Changes Made to Development Permit Documents

Bubbled Set
Changes made to the
Development Permit Application

902 Foul Bay Road
Victoria B.C.

Revised Development Permit Application
April 26, 2024

A1.0

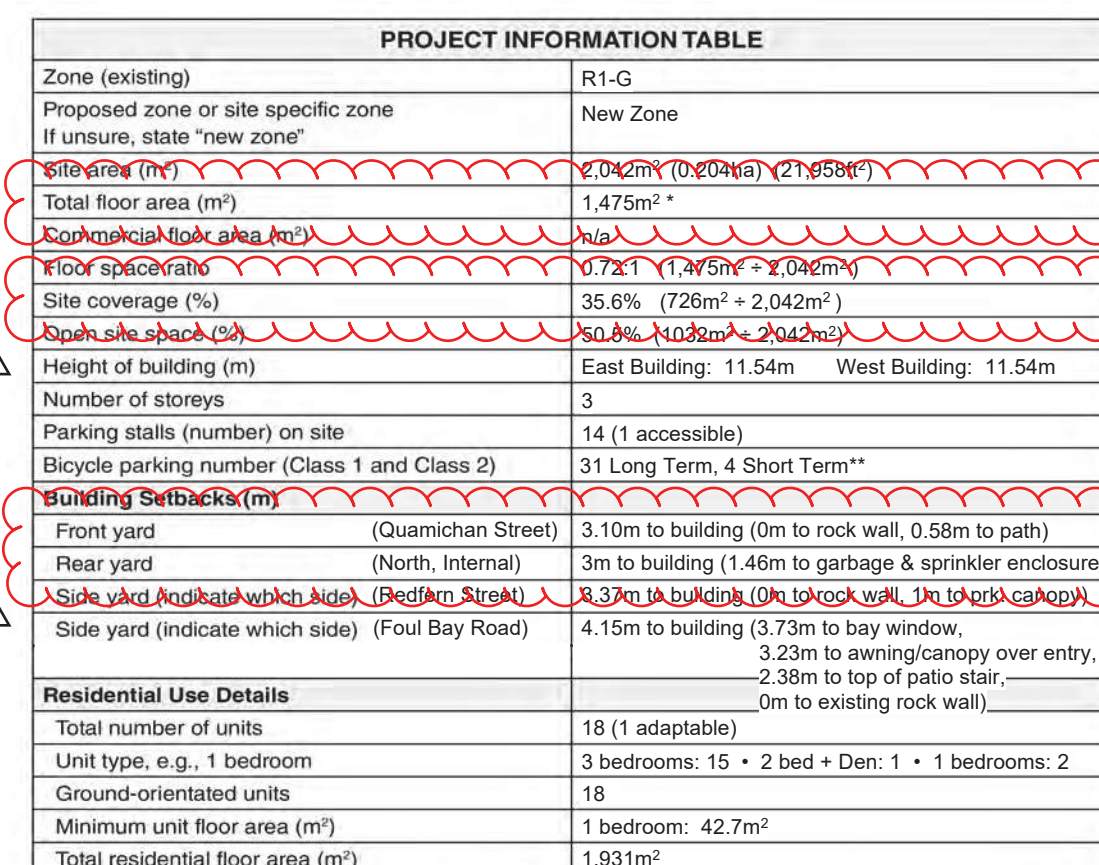
Revision Number	Revision Title	Drawing	Description
1	Parking Canopy Deleted	A1.0	Parking Canopy with green roof has been deleted and stall locations have been adjusted. In place of the green roof, the drive aisle has been changed to permeable paving. Refer to Landscape drawings.
2	Garbage Enclosure	A1.0, A2.5	New garbage enclosure with cedar screening and trellis. New sprinkler closet with conditioned interior space. See revision #7 below.
3	Parking & Bike Parking	A1.0, A2.1w, A3.1	Adjustments to the Bike Storage and adjacent parking stall configuration; Revised electrical room access.
4	Green Roof Deleted	A2.3w	Green roof deleted over 1br units. Standard low-slope roofing remains (2 ply SBS membrane, dark grey). In place of green roof, the drive aisle has been changed to permeable paving (refer to Landscape drawings).
5	Pathways Revised	A1.0	Pathway configuration and materials have changed. Refer to Landscape drawings.

6	Metal Plate Awning Deleted	A3.0, A3.2	Metal plate awnings have been deleted.
7	Grades Updated	A1.0	Grade calculations have been updated in coordination with the detailed site plan & site grading. For reference, building footprints have been added to the site survey. Also refer to change #22 below.
8	Floor Area Updated	A1.0	Floor area calculations have been updated to include the new Sprinkler Closet and refinements to the residential units.
9	Basement Wall Moved	A2.0w	Bathroom wall in Unit W3 has been revised for unit consistency.
10	Entry Porch Reconfigured	A1.0, A2.1w, A2.1e, A3.0, A3.1	Entry porches at Unit W1 and E1 have been revised for unit consistency.
11	Height Dimension	Elevations & Sections	Height dimension added to Elevations and Sections as requested in Zoning Plan Check.
12	Pathway Setback & Site Coverage	Site Plan & Project Data	Quemichan setback taken to edge of pathway as requested in Zoning Plan Check comment. Site Coverage has been adjusted to account for the area of pathway more than 0.6m above natural grade.

21	Existing grade	Elevations & Sections	A dashed line indicating existing grade has been added to elevations and sections.
22	Grade Calculations	A1.0 Site Plan, A2.0	Grade calculation tables now show data to three decimal places and the subtotals display correctly. West Building grade calculation has been revised around the entry to Unit W1 to exclude the ramp structure. To maintain grade and avoid larger changes, one window well (noted on the Site Plan) has been made Code minimum and excluded from the calculations (grade points 22 to 24 are now existing/natural).

9 A3.4

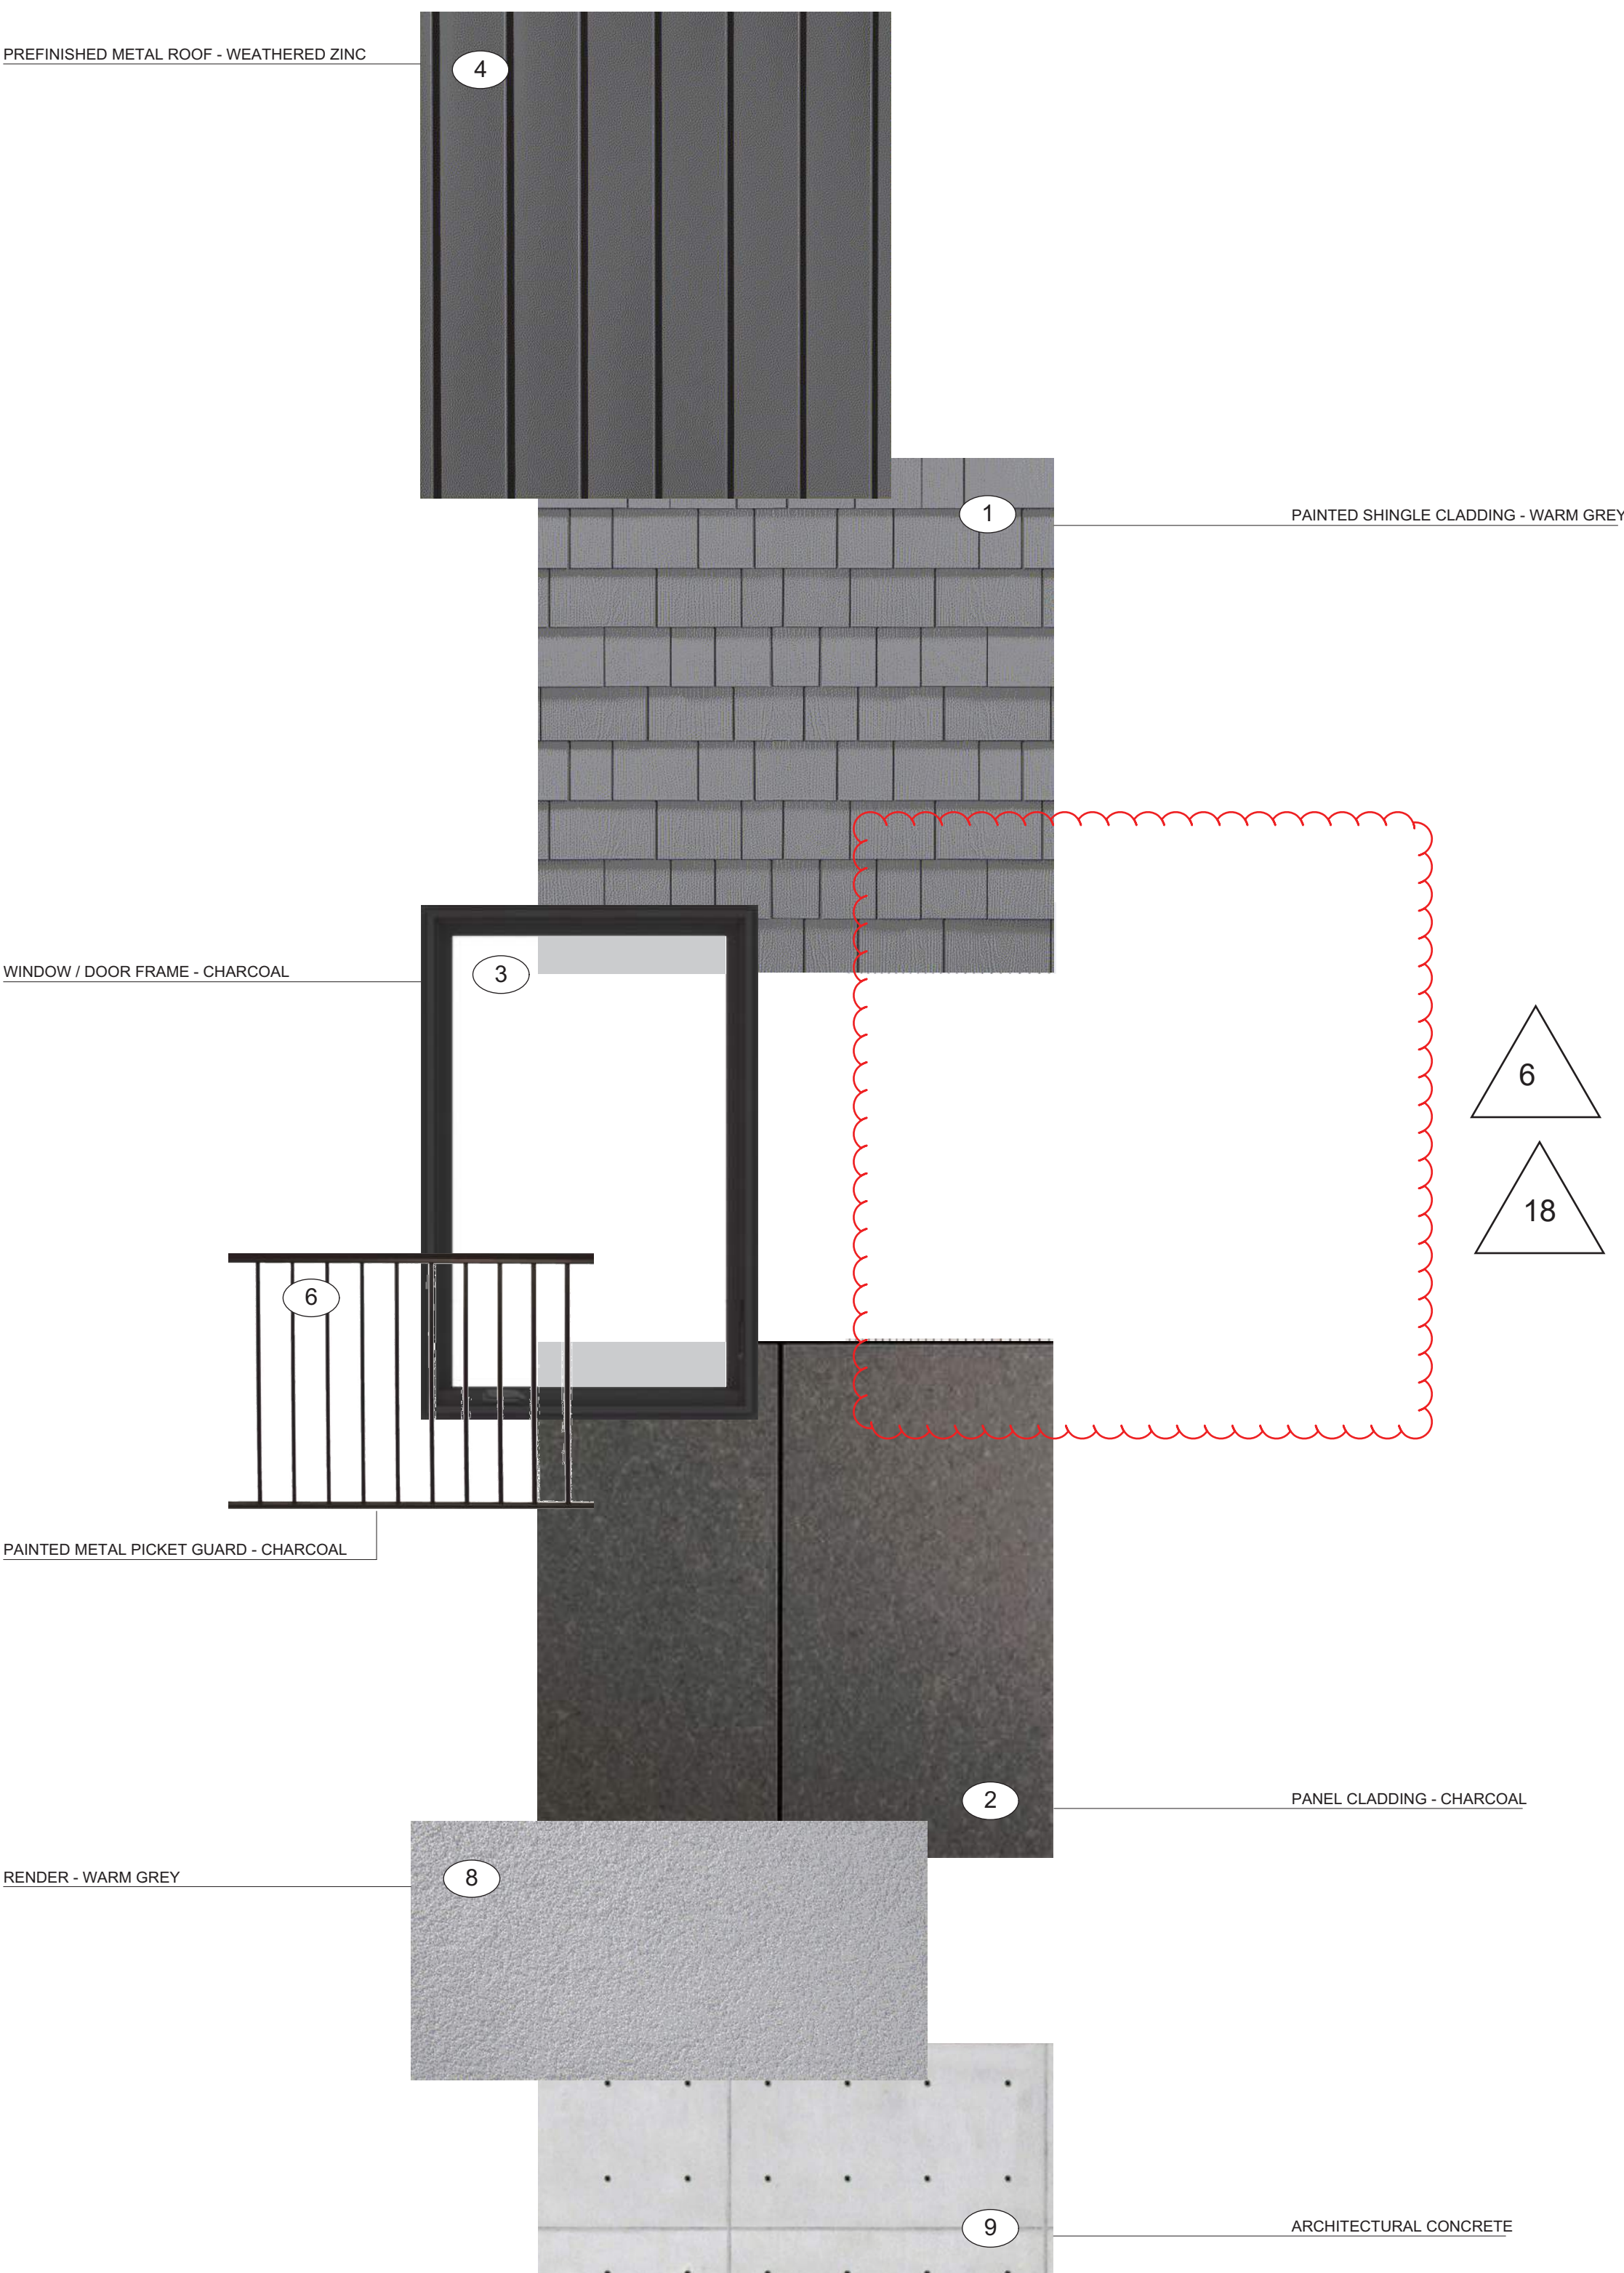
17	Section Label Revised	A4.1	Section drawing labels revised to "East Building", "West Building" and "Site" in response to Zoning Plan Check Comment.
18	Materials Palette Added	A3.4	Added back into set with new sheet number. Material #7 has been deleted and replaced (see revision #6 above).
19	Stairs & Retaining Walls Adjusted	Site Plan & A2.1w	At the West Building, entry porch stairs have been reduced in length and window well retaining walls have shifted east to suit refinements in finished grade. Grade points at retaining walls and new building corners have been re-extrapolated from the survey. See revision #7 above.
20	Stairs Adjusted & New Retaining Walls	Site Plan & A2.1e	At the East Building, window wells have been added and entry porch stairs have been adjusted in length to suit refinements in finished grade. Grade points at new building corners and retaining wall steps have been re-extrapolated from the survey. See revision #7 above.
